# ATS & PSFP YANG maintenance items #0392 & #0393 ver 3.0

# Maintenance items

# #0392 Updates

# #0393 Update for Bridge

Figure 48-16—Asynchronous Traffic Shaping model

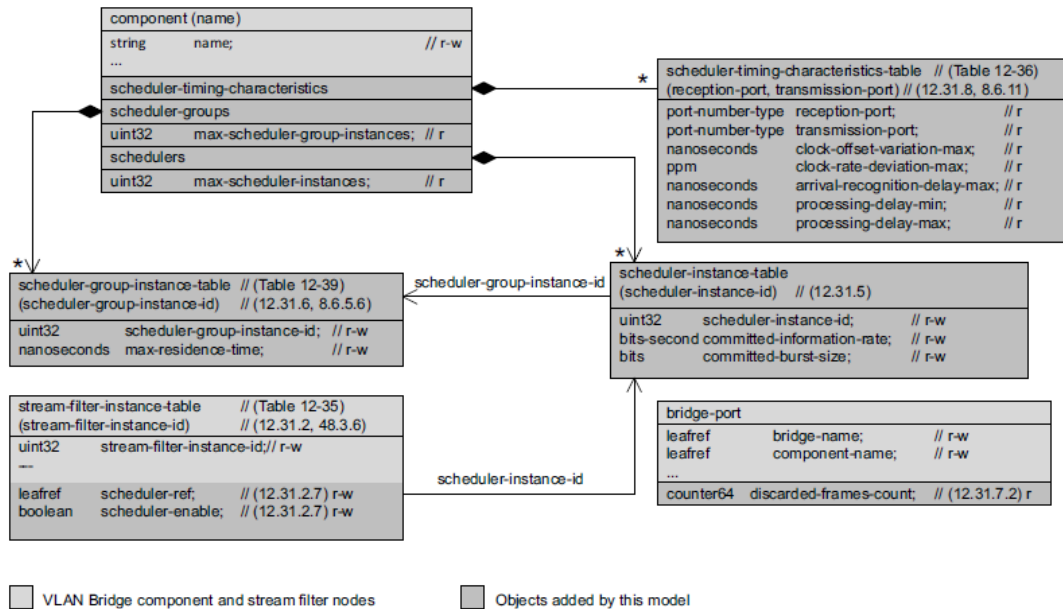
- The ATS model augments the Bridge component model (48.3.1) and the stream filters and stream gates model (48.3.6) by nodes that represent to following managed objects:

- a) The Scheduler Instance Table (12.31.5)
- b) The Scheduler Group Instance Table (12.31.6)
- c) The Scheduler Port Parameter Table (12.31.7)
- d) The Scheduler Timing Characteristics Table (12.31.8)
- e) A Stream Filter specification type representing an ATS scheduler instance identifier (12.31.2.5)

- **Current ieee802-dot1q-ats-bridge.yang**
  - *ats:ats-parameters* is under augment of “stream-filters/stream-filter-instance-table”
  - It creates multiple ***the Scheduler Instance Table (12.31.5)*** and ***the Scheduler Group Instance Table (12.31.6)*** under ***the Stream Filter Instance Table (12.31.2)*** than one per the Bridge Component.

- No change needed on **ieee802-dot1q-ats.yang**
- Modified **ieee802-dot1q-ats-bridge.yang**
  - Move *ats:ats-parameters* out of augment of “stream-filters/stream-filter-instance-table”
  - It creates ***single Scheduler Instance Table (12.31.5)*** and ***single Scheduler Group Instance Table (12.31.6)*** under the Bridge Component.

# New 802.1DC ATS YANG schema

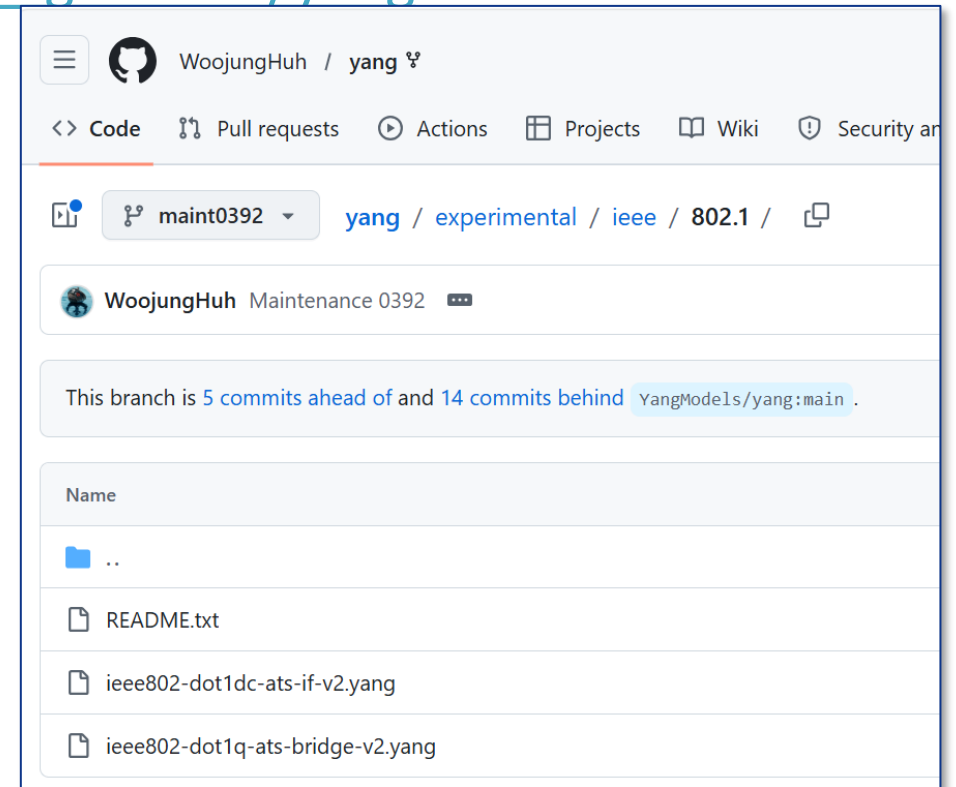
- *ats:ats-parameters* is under augment of “stream-filters/stream-filter-instance-table”
- It creates multiple ***the Scheduler Instance Table (12.31.5)*** and ***the Scheduler Group Instance Table (12.31.6)*** under ***the Stream Filter Instance Table (12.31.2)*** than one per the Bridge Component.

- **Modified ieee802-dot1dc-ats-if.yang**
  - Move *ats:ats-parameters* out of augment of “stream-filters/stream-filter-instance-table”
  - It creates ***single Scheduler Instance Table (12.31.5)*** and ***single Scheduler Group Instance Table (12.31.6)*** under the Bridge Component.

Figure 8-13—Flow classification and metering

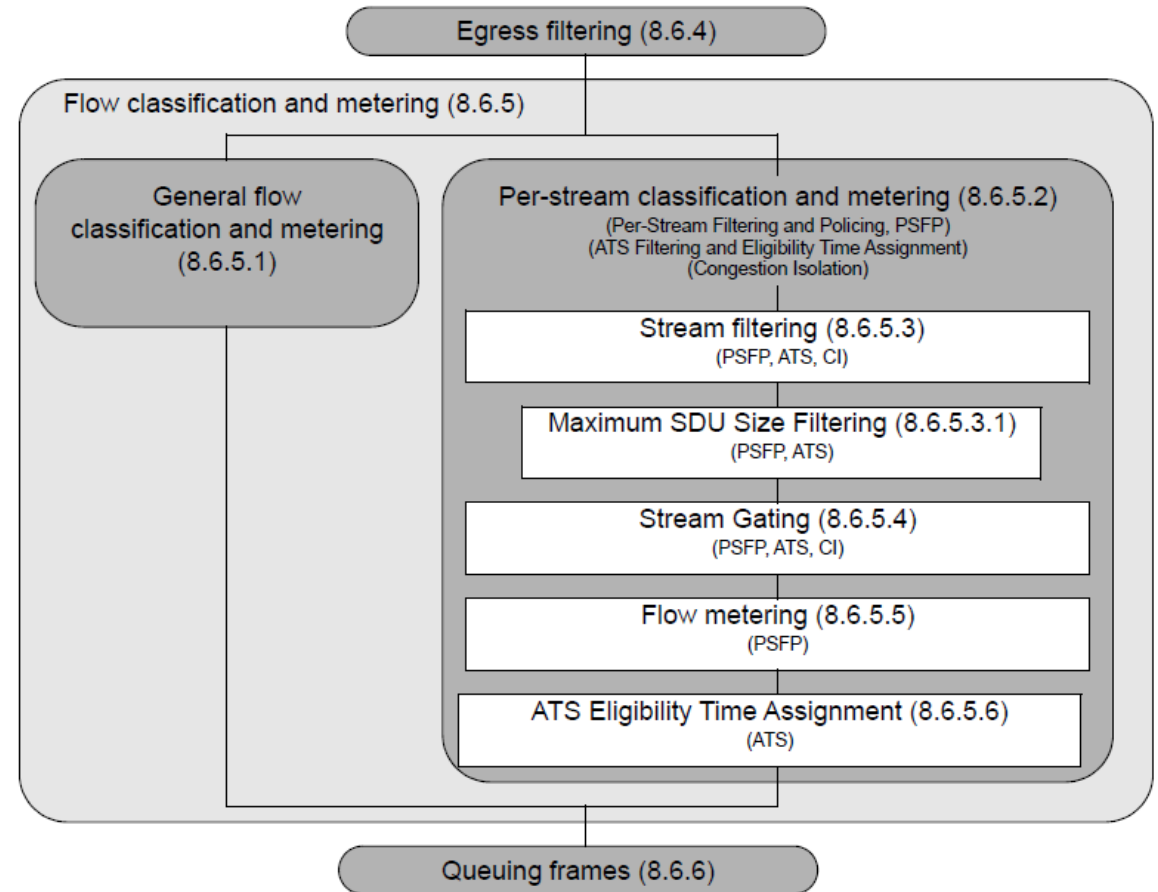
- **8.6.5 states**
  - “PSFP and ATS share common per-stream classification and metering elements, as shown in Figure 8-13.”
- **8.6.5.2 d) states**
  - “... A given stream filter can be configured with flow meters and an ATS scheduler if both PSFP and ATS are supported.”
- **8.6.5.2.2 b) states**
  - “If the Bridge component does not support PSFP in addition to ATS, each stream gate only supports IPV assignment. ...”
  - NOTE 2—For bridges with support for ATS, and without support for PSFP, stream gates of ATS traffic will never close. In this case, stream gates are only used for IPV assignment.

# Usage of Stream Filters and Stream Gates

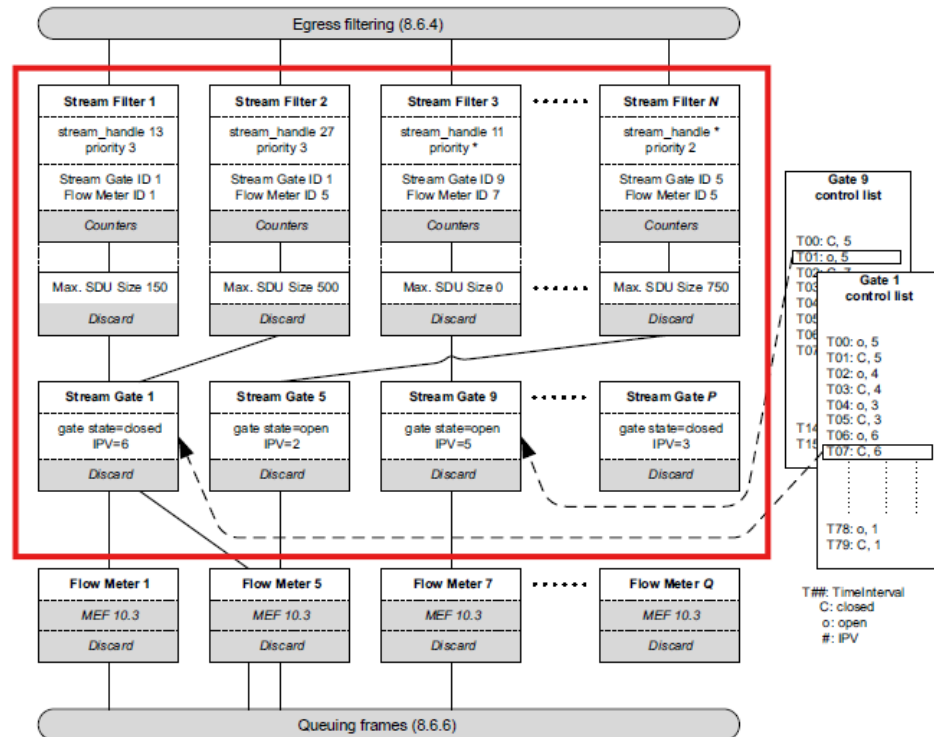
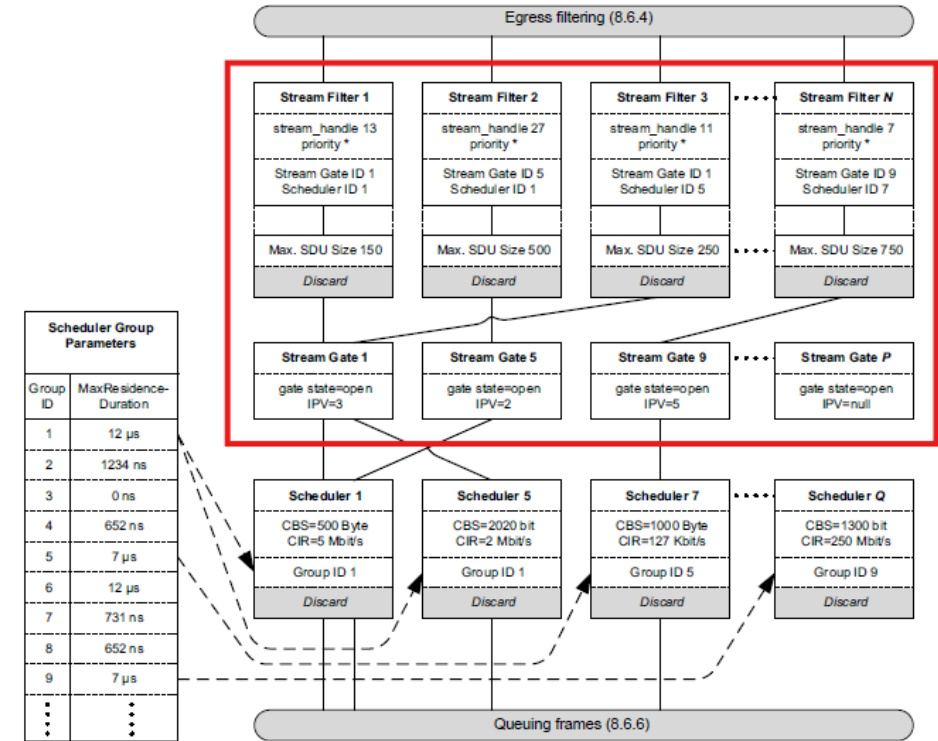
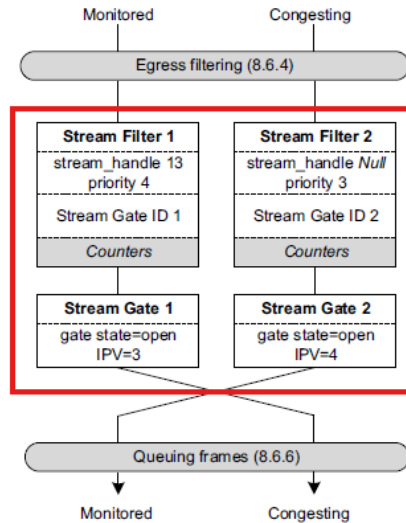
- **Stream gates**
  - Shared by PSFP, ATS, CI
- **Stream Filters**
  - Shared by PSFP, ATS, CI
- **Flow Meters**
  - Used by PSFP

# Number of Instance Tables

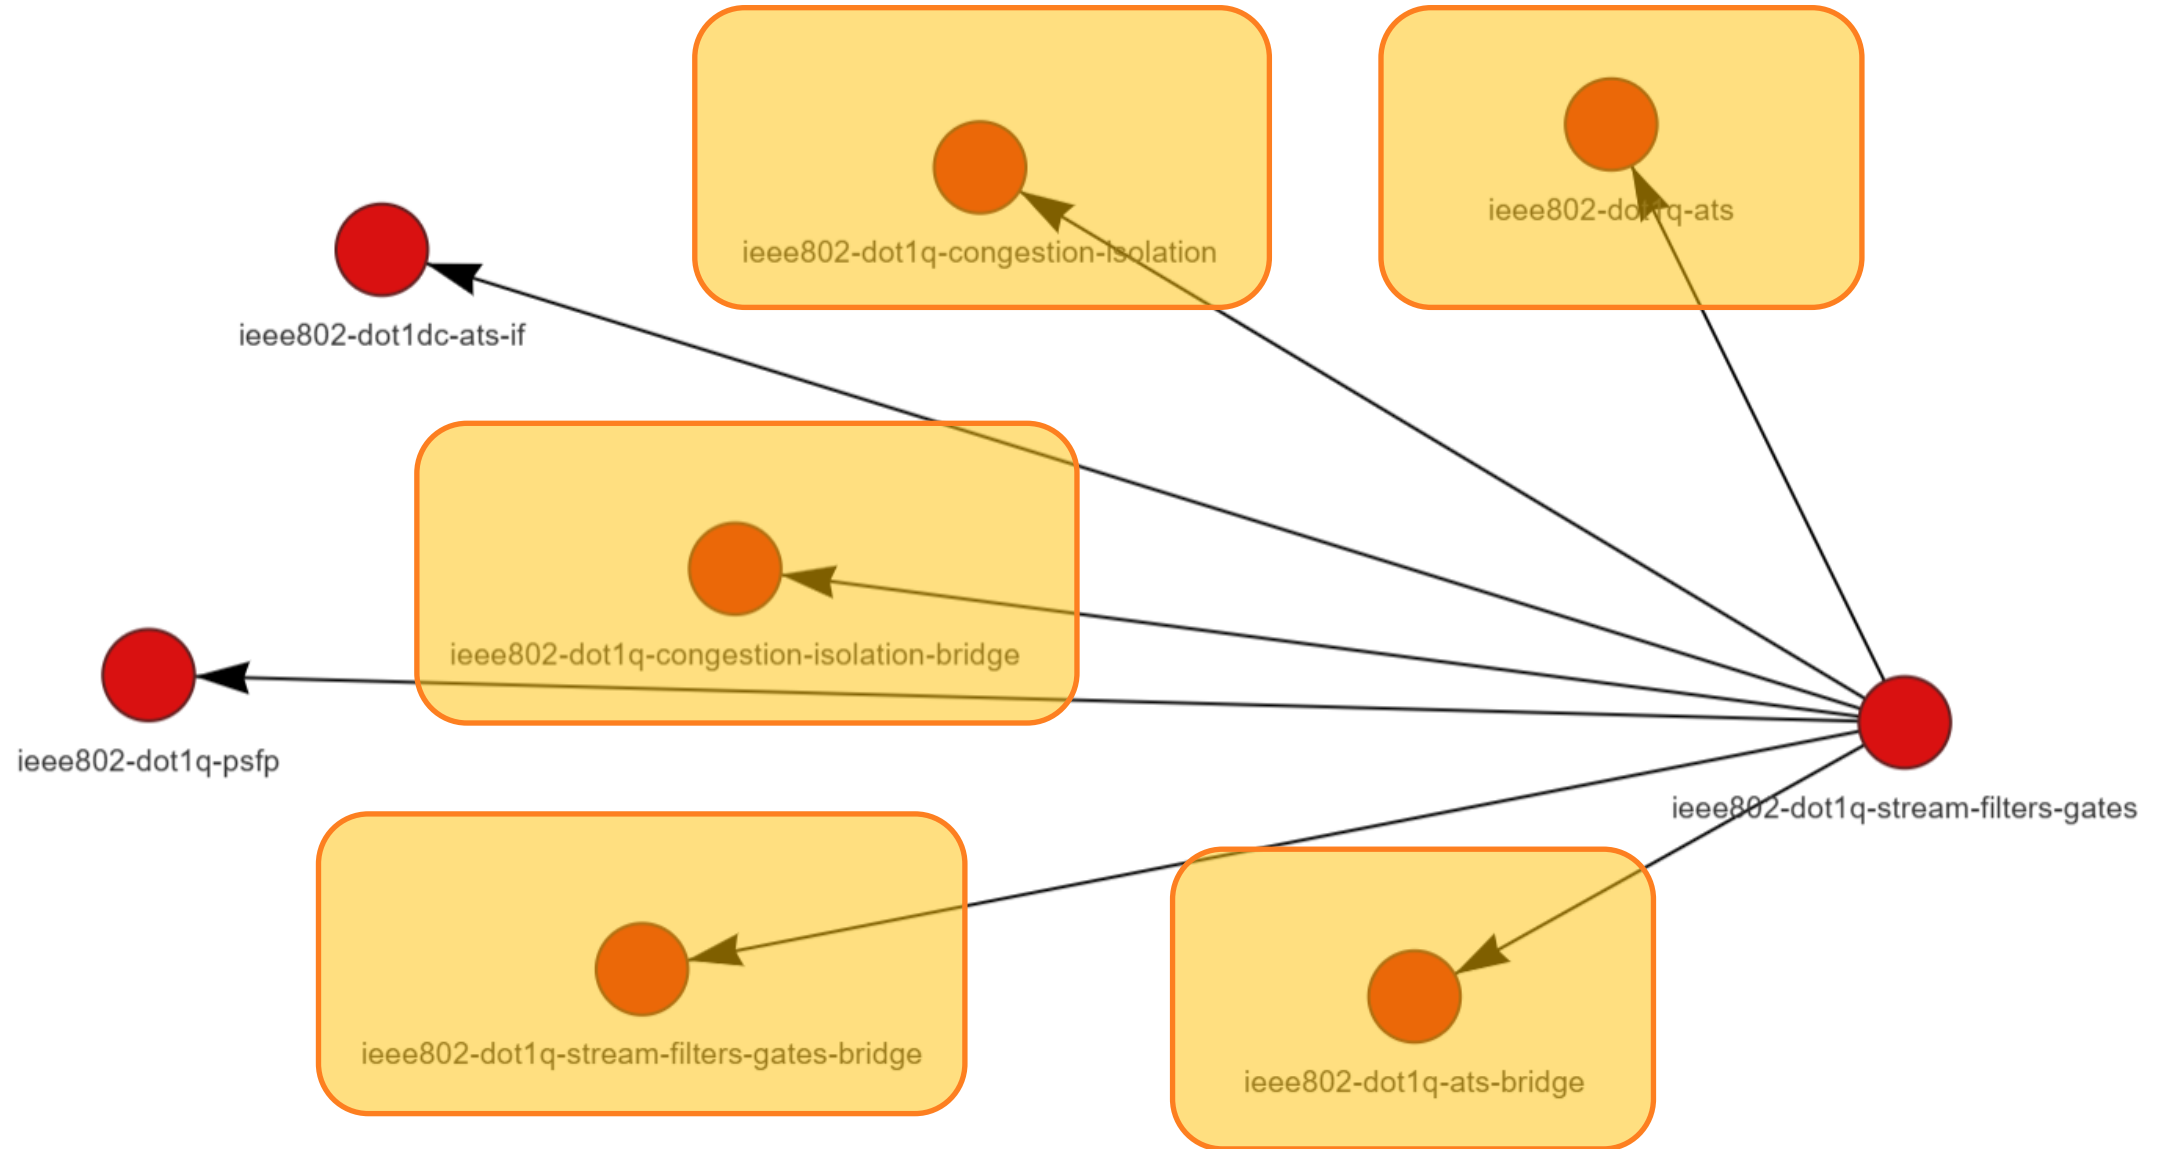
- **12.31.2 The Stream Filter Instance Table**
  - There is one Stream Filter Instance Table per Bridge Component.
- **12.31.3 The Stream Gate Instance Table**
  - There is one Stream Gate Instance Table per Bridge Component.
- **12.31.4 The Flow Meter Instance Table**
  - There is one Flow Meter Instance Table per Bridge component.

# sfsg:sfsg-parameters reference analysis

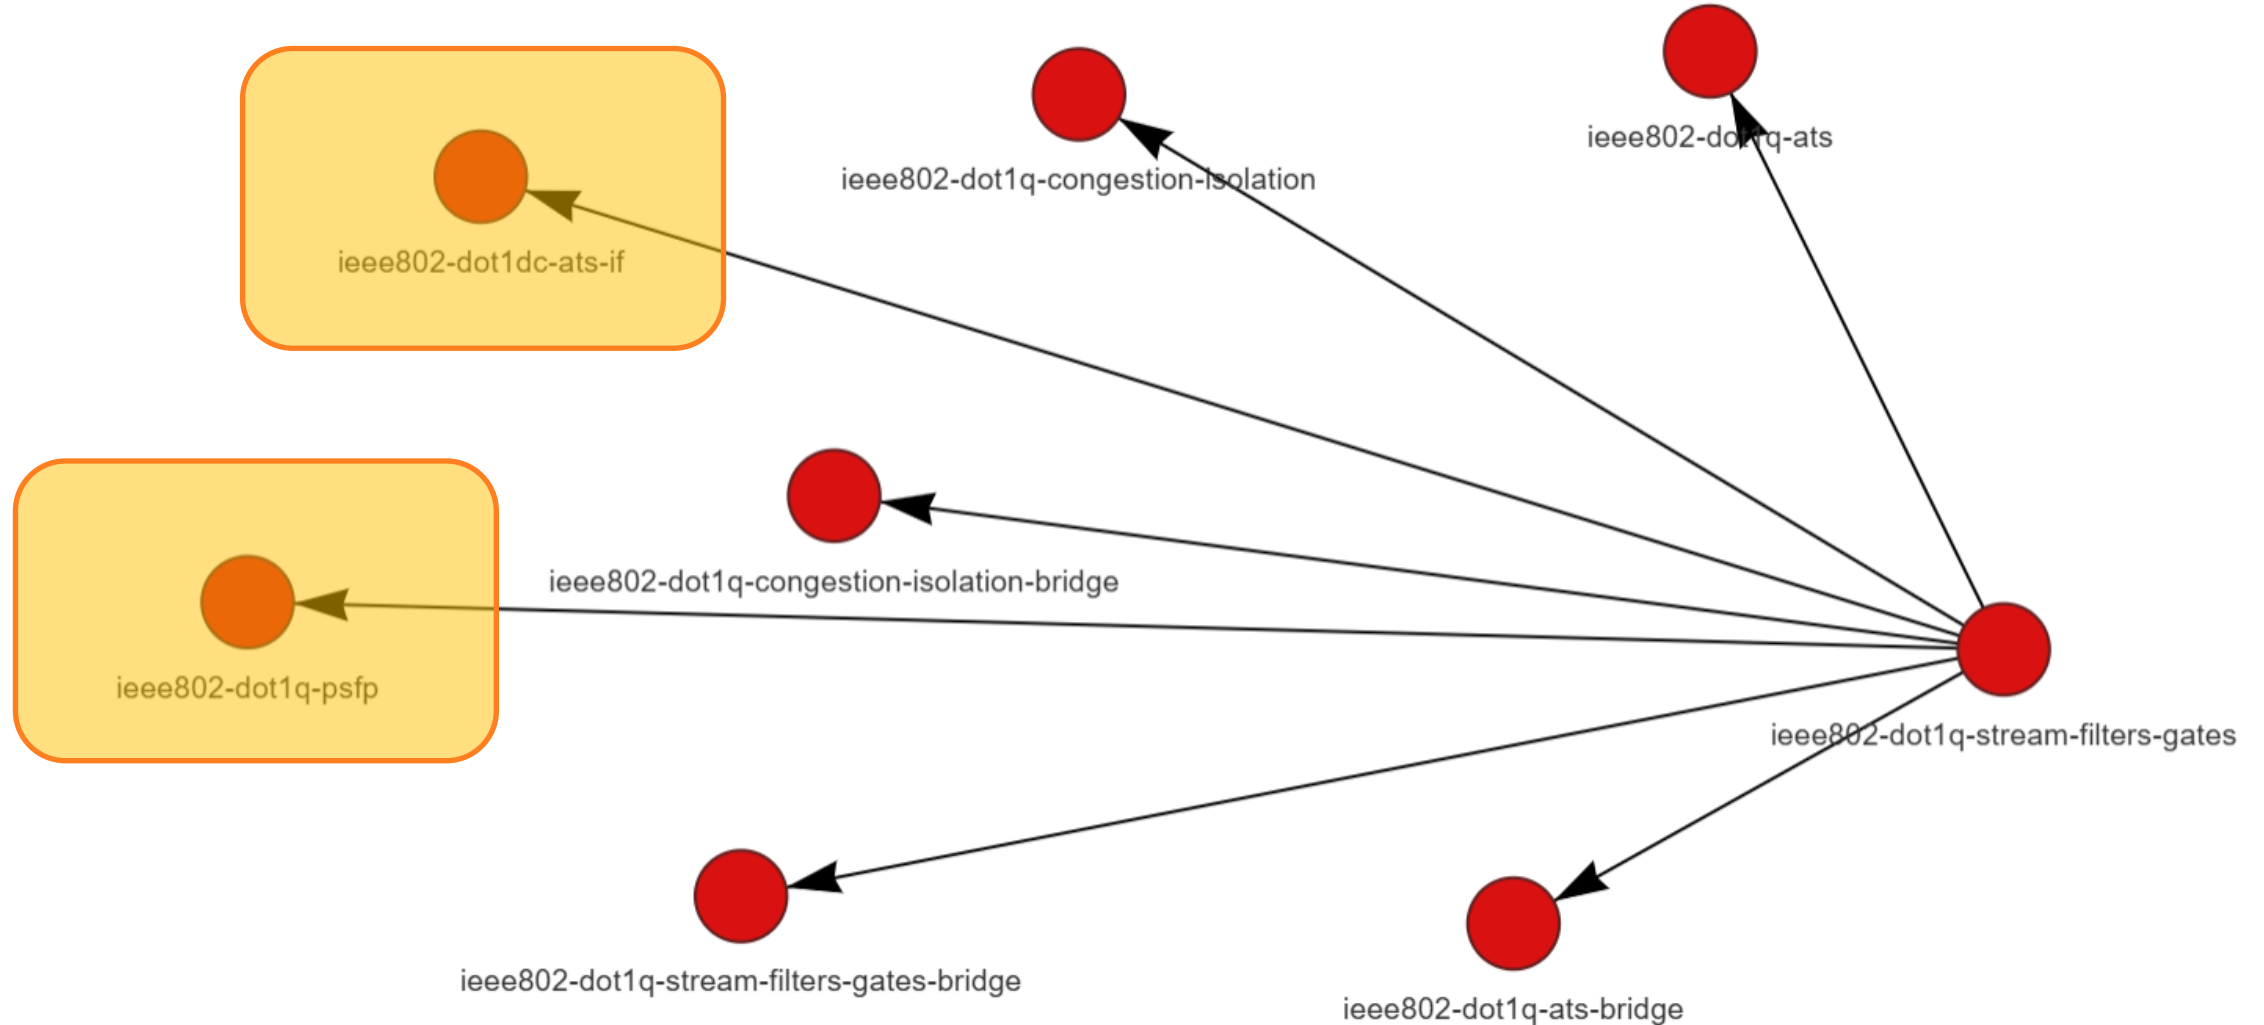
- **Current implementation**
  - Define “*grouping sfsg-parameters*” in ieee802-dot1q-stream-filters-gates.yang
  - Uses “*uses sfsg:sfsg-parameters*” in 3 modules of ieee802-dot1q-[ats/psfp/congestion-isolation]-bridge.yang
- **Problem**
  - “*Uses*” statement copies the nodes defined by the “*grouping*” into the current schema tree.
  - This creates **own Stream Filter and Stream Gate of each module** under the bridge component.

- **Current implementation**
  - Define “*grouping sfsg-parameters*” in ieee802-dot1q-stream-filters-gates.yang
  - Uses “*uses sfsg:sfsg-parameters*” in ieee802-dot1dc-psfp-sys.yang (from ieee802-dot1q-psfp.yang) and ieee802-dot1dc-ats-if.yang
- **Problem**
  - “*Uses*” statement copies the nodes defined by the “*grouping*” into the current schema tree.
  - This creates **own Stream Filter and Stream Gate of each module** under the bridge component.

- **Removing “use sfsg:sfsg-parameters” in**
  - ...ats-bridge.yang, ...psfp-bridge.yang (i.e., ...pspf.yang) and ...congestion-isolation-bridge (i.e., ..congestion-isolation.yang)
  - ...ats-if.yang, & ...psfp-sys.yang
- **Use a base modules**
  - ieee802-dot1q-streams-filters-gates-bridges.yang for bridge functions
    - for bridge (802.1Q) : sfsg-bridge
  - ieee802-dot1dc-streams-filters-gates-sys.yang for system functions
    - for system (802.1DC) : sfsg-sys
- **Each module augment into base node created by base modules**
  - sfsg-bridge
  - ats-bridge
  - psfp-bridge
  - ci-bridge
